MARKHAM ST. JUMP START IMPVTS. (CONWAY) (S) F.A.P. STPU-9095(33) ARDOT JOB 080566

MARKHAM ST. JUMP START IMPVTS.
(CONWAY) (S)

REV.	DATE	DESCRIPTION
Δ	10/14/2019	CHANGE ORDER NO. 1 - REVISE INDEX OF SHEETS

TYPICAL SECTIONS
 (SHEET 2 OF 7)

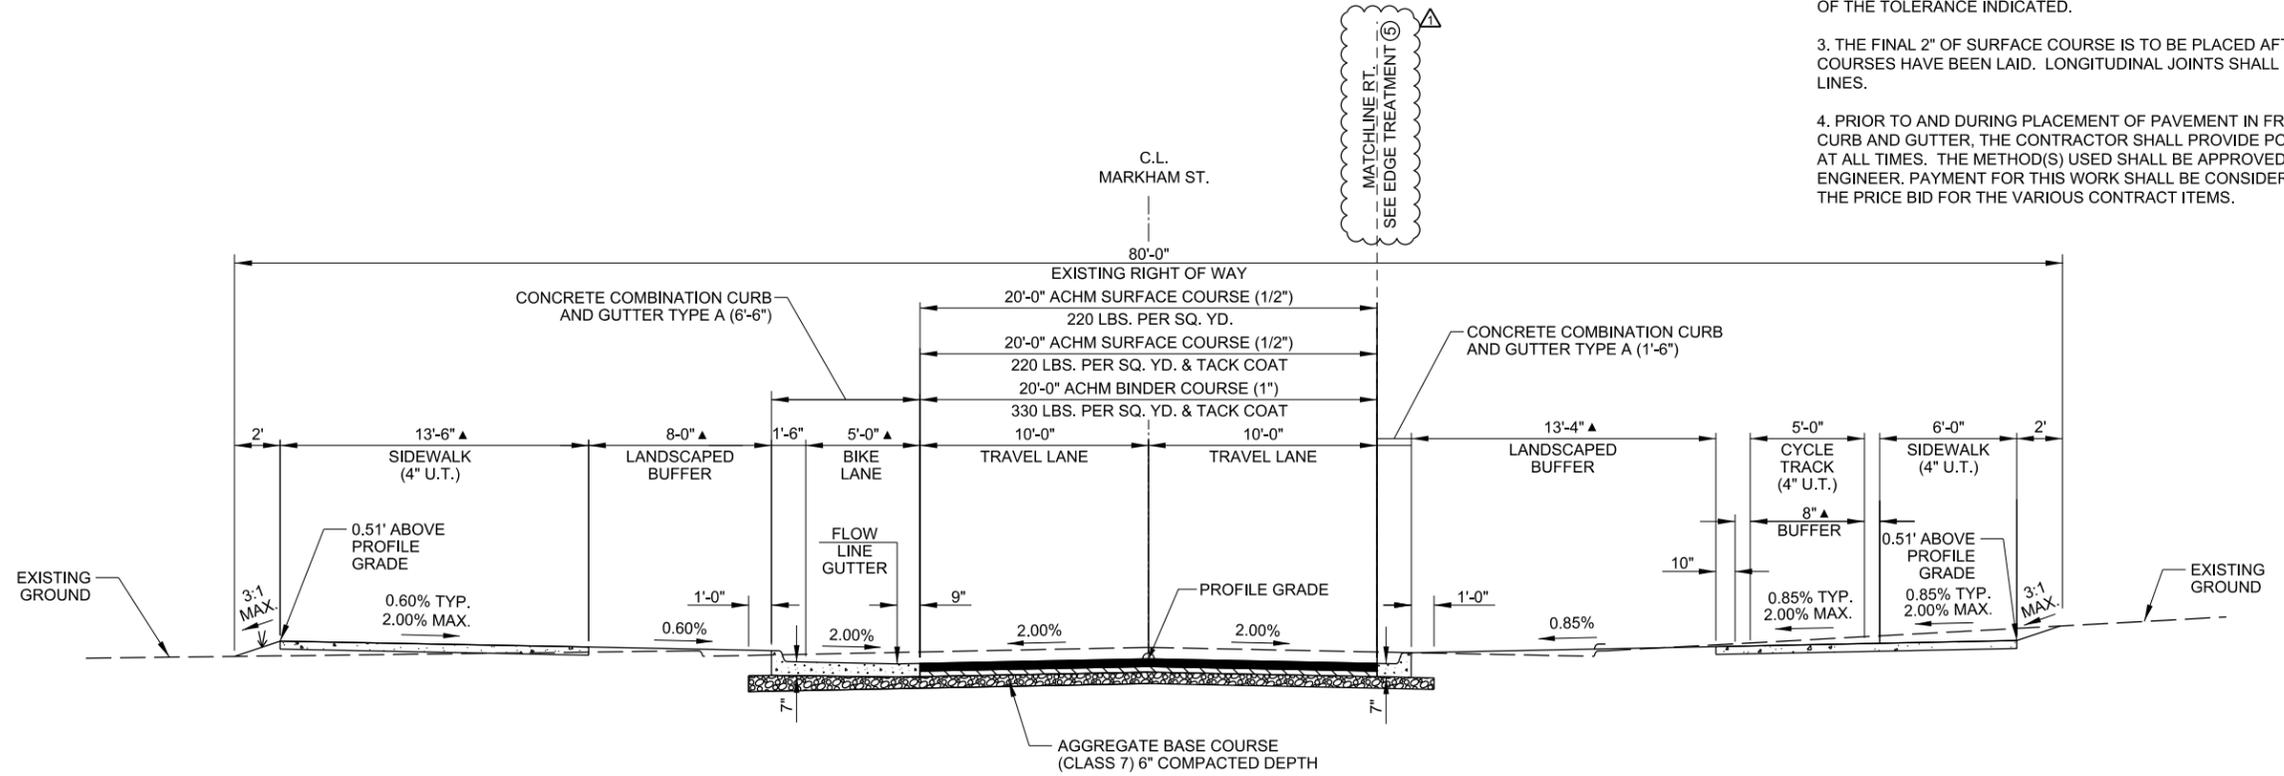
REV.	DATE	DESCRIPTION
1	10/14/2019	CHANGE ORDER NO. 1 - ADD STATION RANGES AND EDGE TREATMENT

LAYOUT DETAILS
(SHEET 1 OF 4)

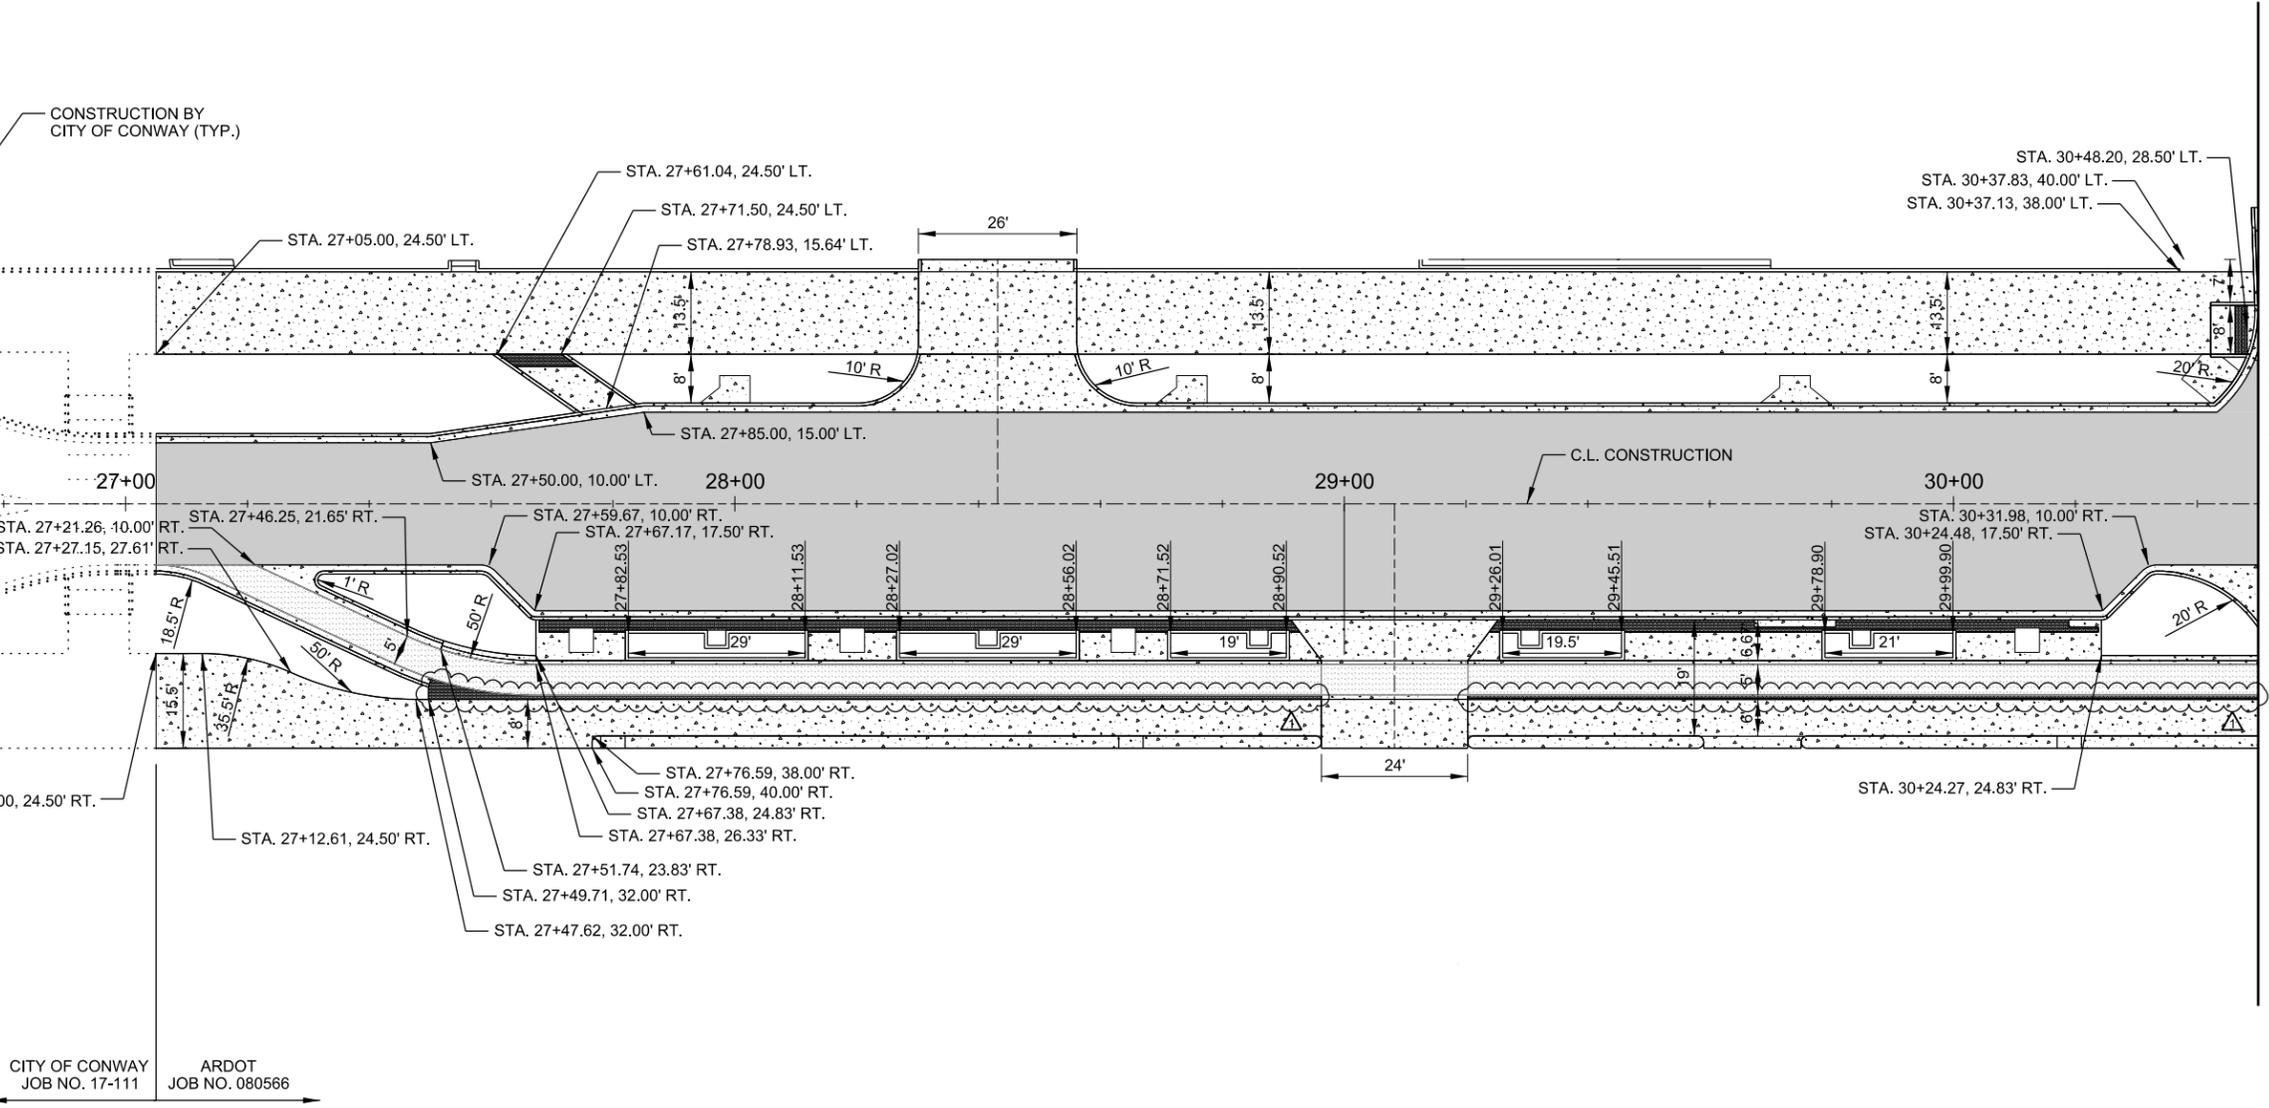
REV.	DATE	DESCRIPTION	BY
Δ	10/14/2019	CHANGE ORDER NO. 1 - ADD BRICK PAVER BUFFER	DLT

LAYOUT DETAILS
(SHEET 3 OF 4)

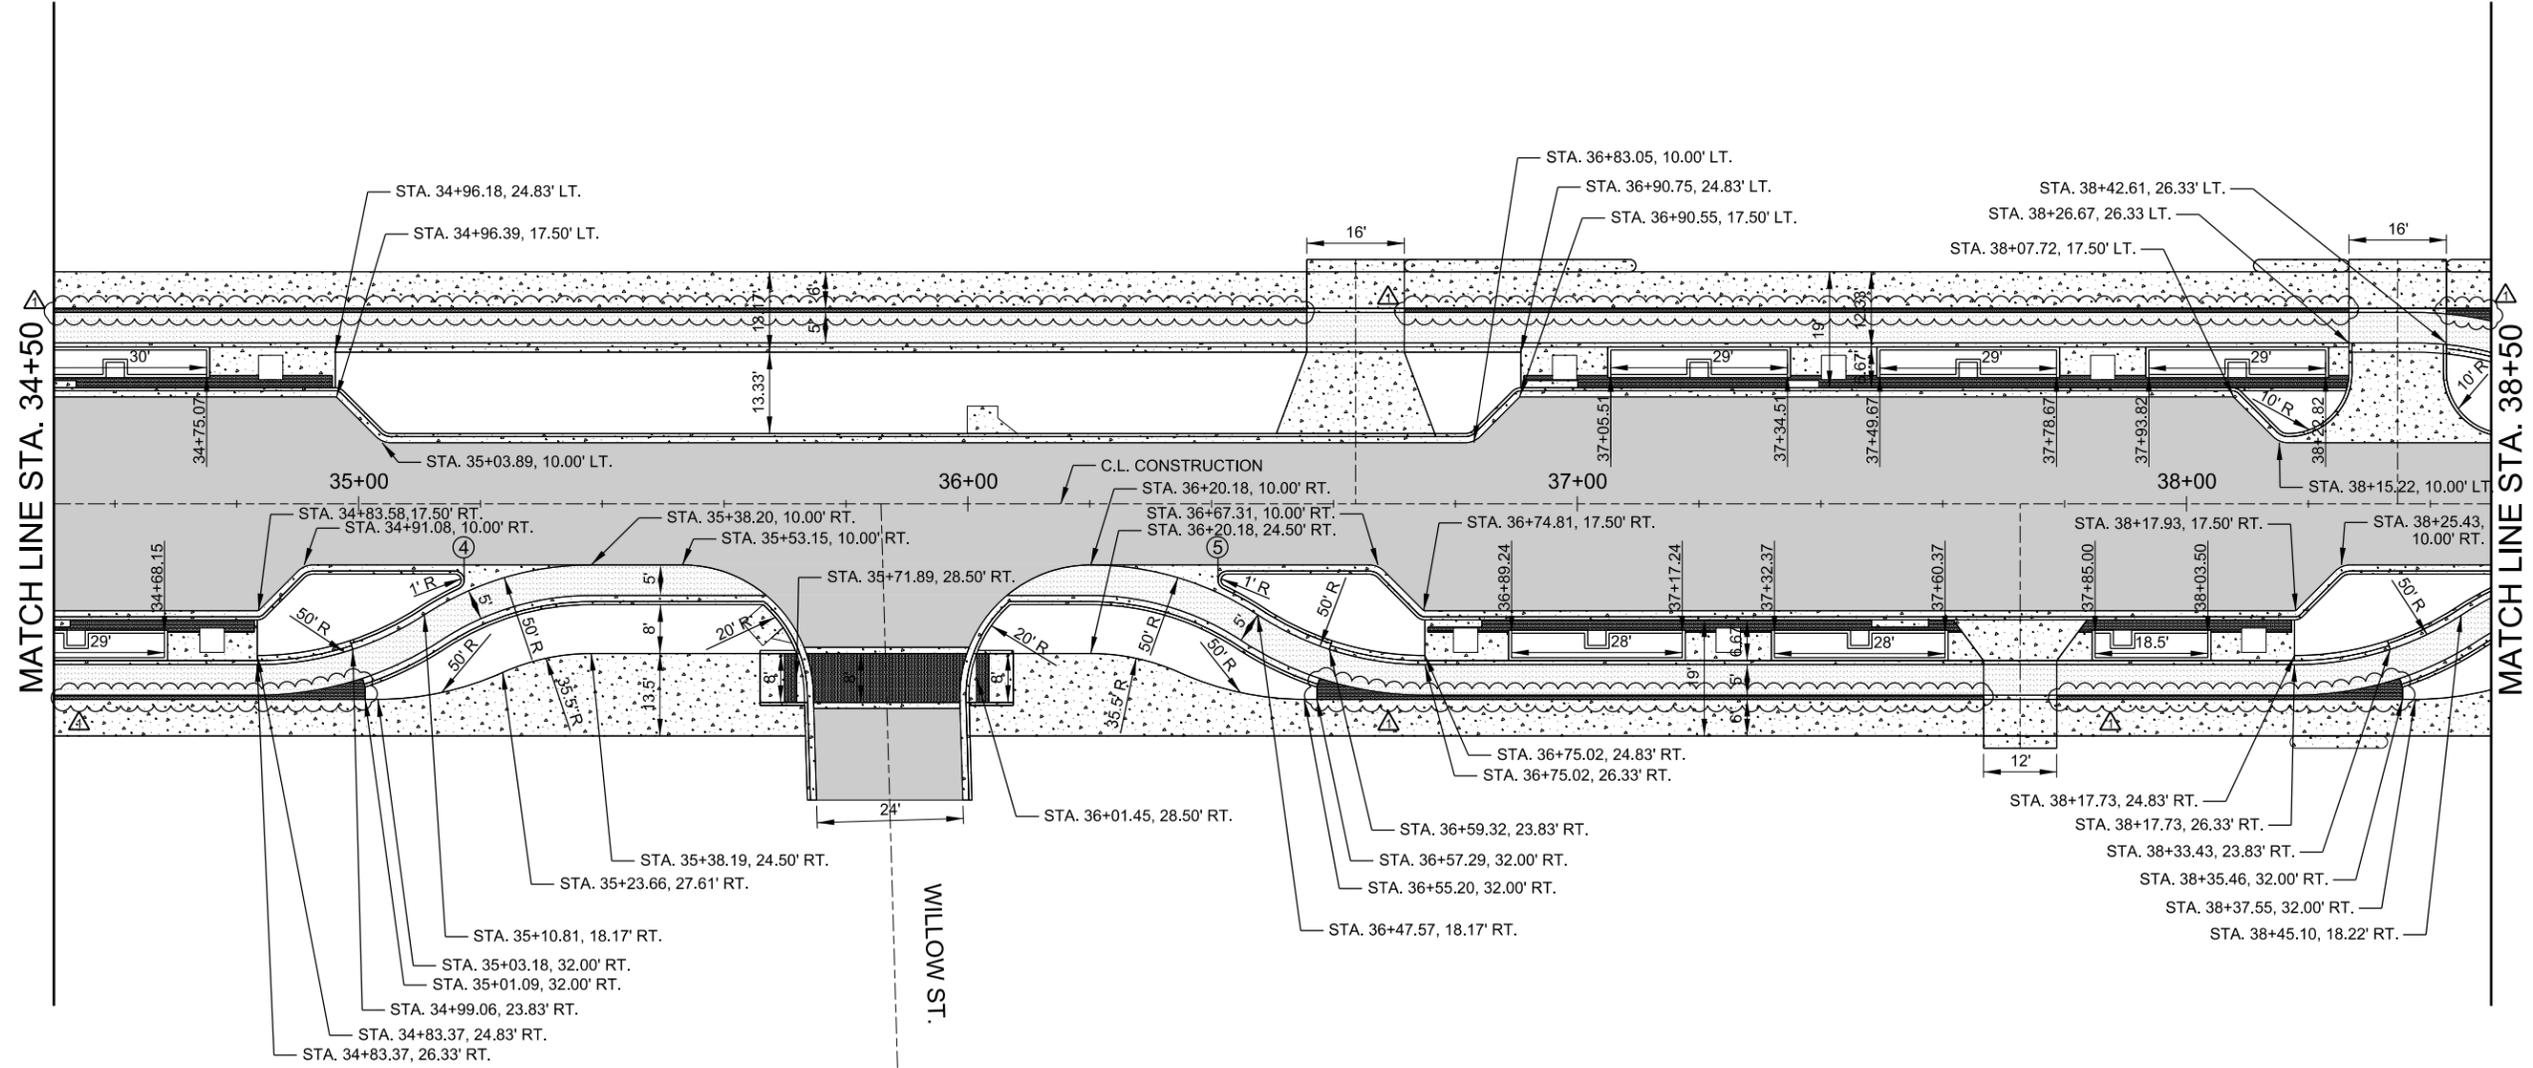
REV.	DATE	DESCRIPTION
Δ	10/14/2019	CHANGE ORDER NO. 1 - ADD BRICK PAVER BUFFER

LAYOUT DETAILS
 (SHEET 4 OF 4)

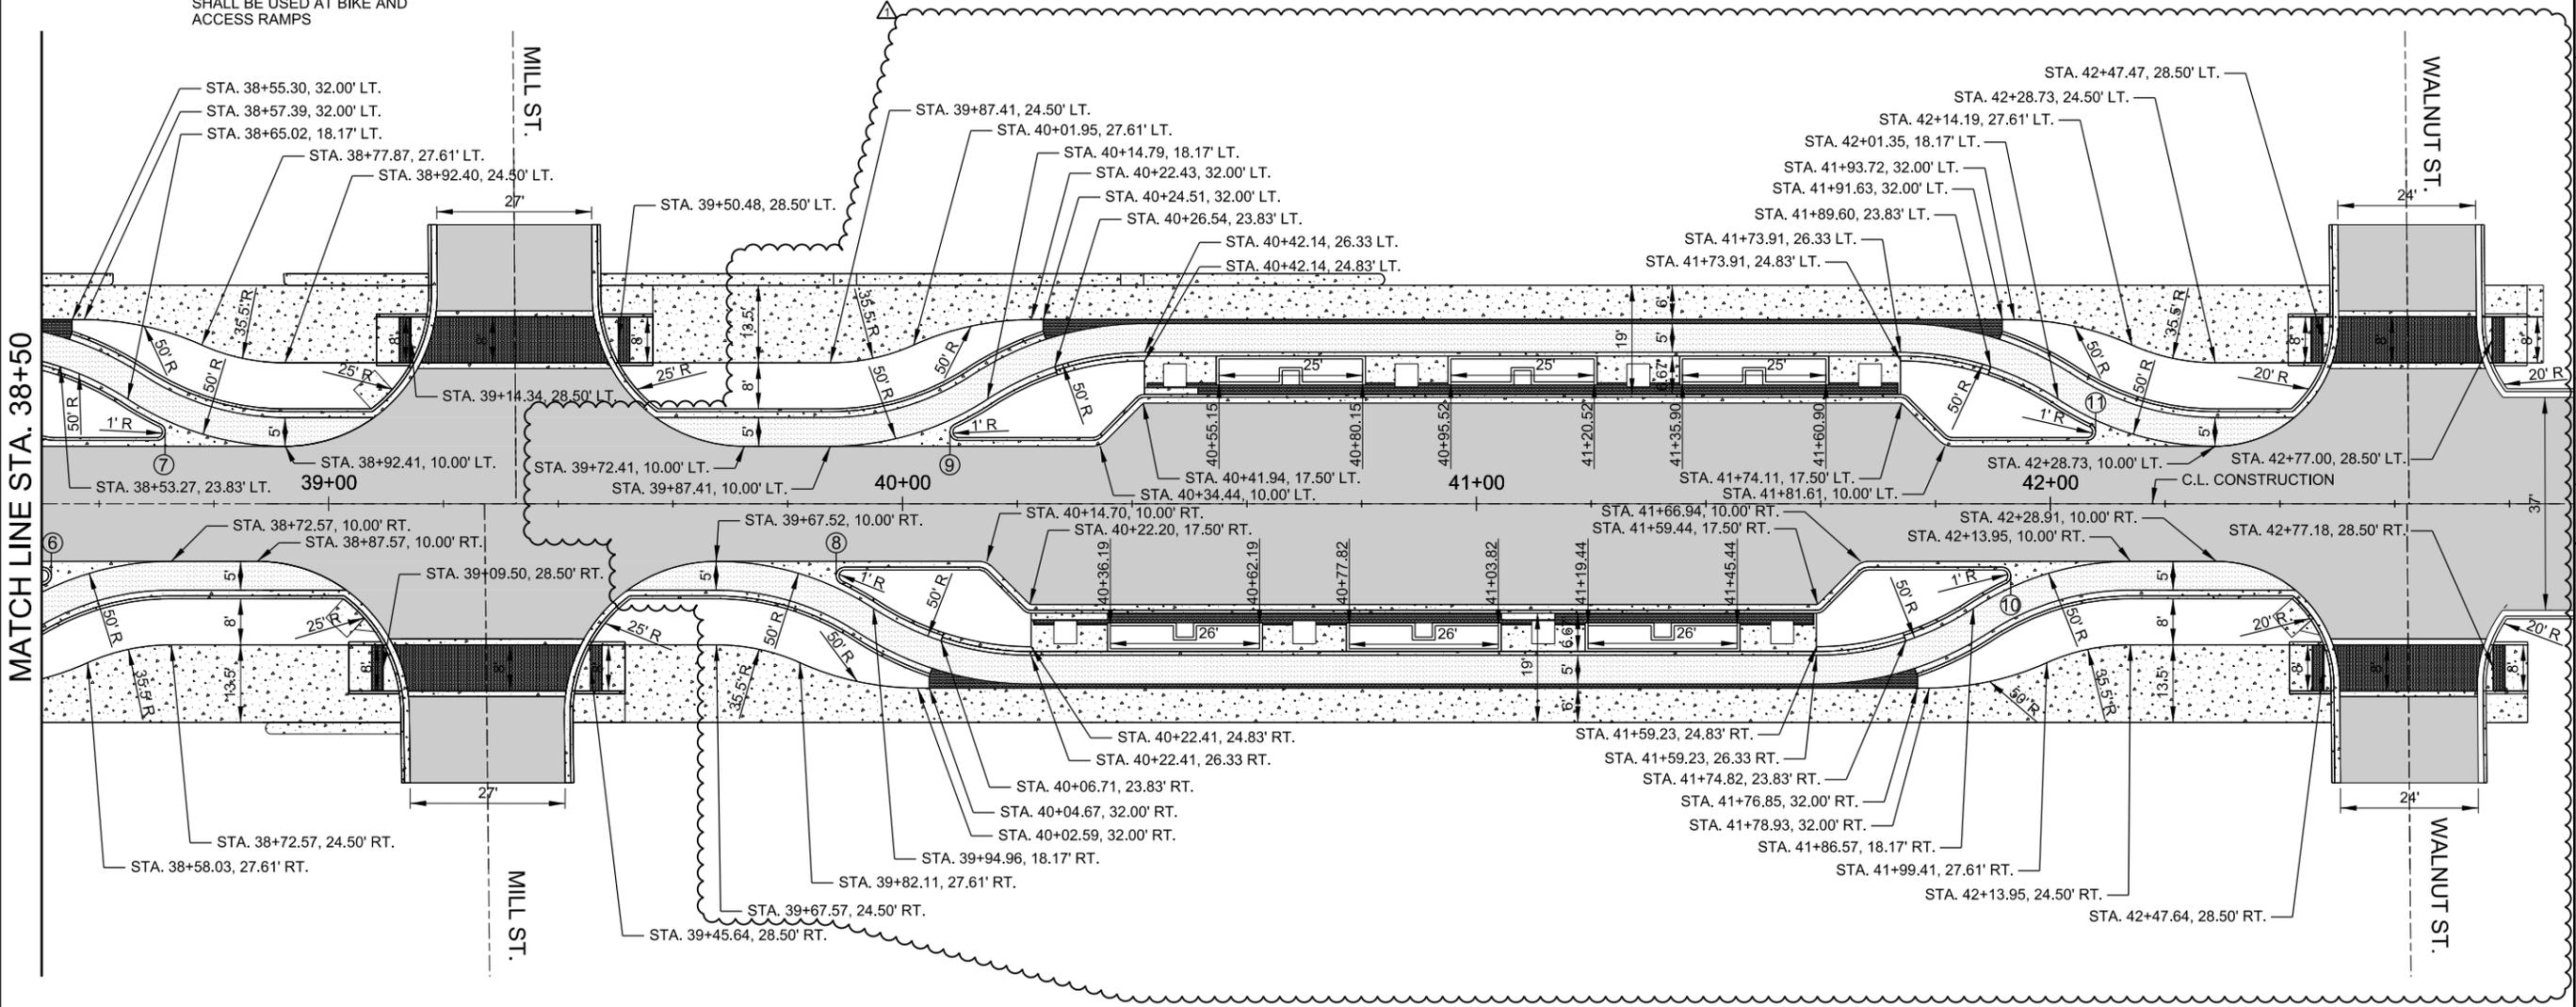
REV.	DATE	DESCRIPTION
1	10/14/2019	CHANGE ORDER NO. 1 - REVISE LAYOUT MILL TO WALNUT AND ADD CURB NOSE LOCATIONS
